Work Order ID 105204

Item Name: Crosstube Turning Detail

DART AEROSPACE LTD		Work Order: 105204
Description: Crosstube Assembly (205/212/412 High Fwd)		Part Number: D212-664-141
Inspection Dwg: D212-664-141 Rev: D		Page 1 of 2

DRAWING NO. D212-664-141	TITLE XTUBE ASSY (205/212/412 HI FWD)	REV. D	DART AEROSPACE LTD ENGINEERING ORDER		D.E.O. NO. D212-664-141-D-1	SHEET NO. SHEET 1 OF 2	SCALE NTS
DRAWN	CHECKED	MFG. APPR.	APPROVED	DE APPR.			
DATE 11.04.07	DATE 11.04.11	DATE 11.04.12	DATE 11/04/12	DATE 11.04.12

**D212-664-141/-141B
ASSEMBLY DETAIL**

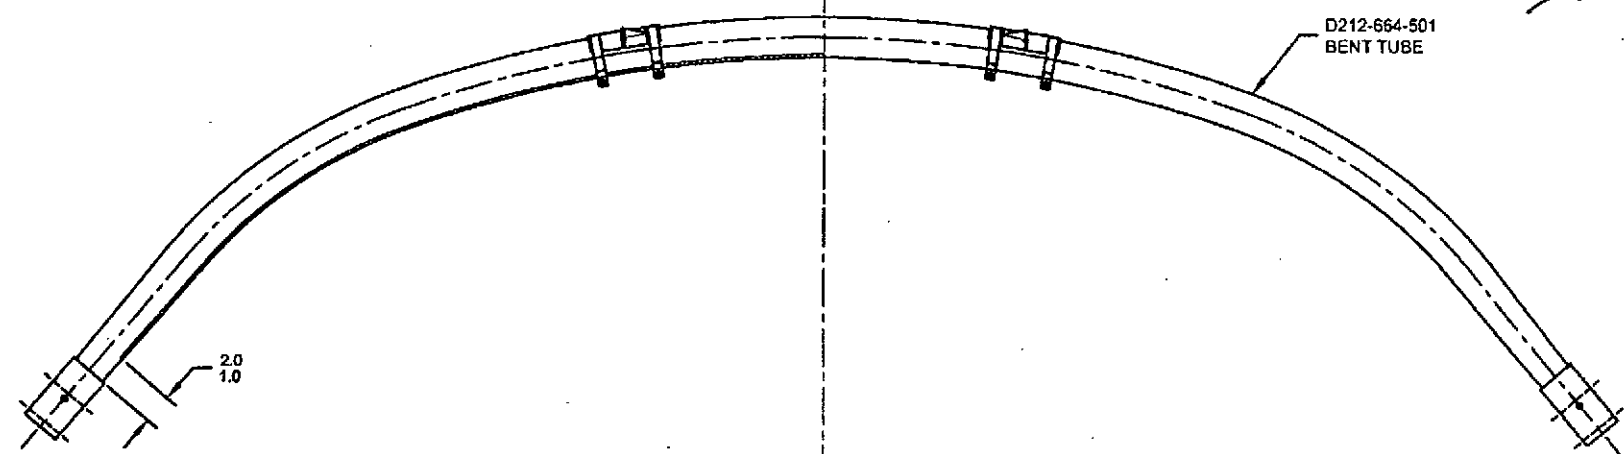
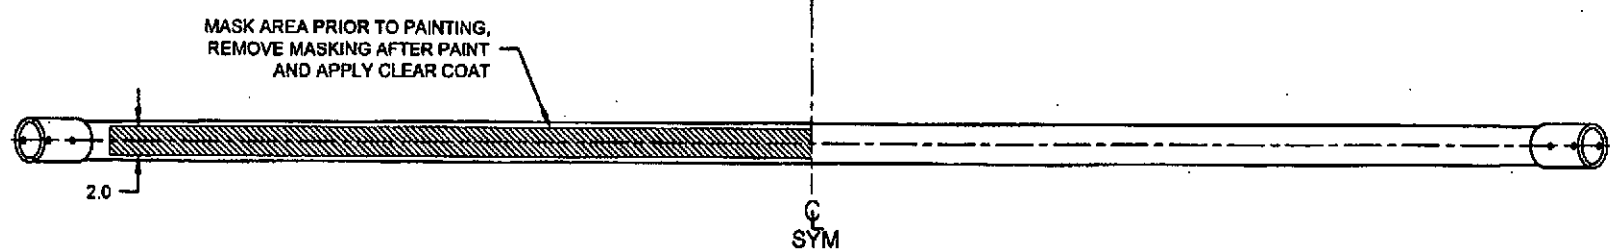
PURPOSE:

ADD AN INSPECTION WINDOW TO UNDERSIDE OF CROSSTUBE.

NOTES 2 OF SHEET 1 IS AMENDED AS FOLLOWS:

IS:

WAS:

- 2) FINISH: CHEMICAL CONVERSION COAT PER DART QSI 005 4.1
PRIME INSIDE AND OUTSIDE PER DART QSI 005 4.2
MASK UNDERSIDE OF CROSSTUBE AS SHOWN (HATCHED AREA) AND
PAINT OUTSIDE PER DART QSI 005 4.2
REMOVE MASKING AND APPLY CLEAR COAT
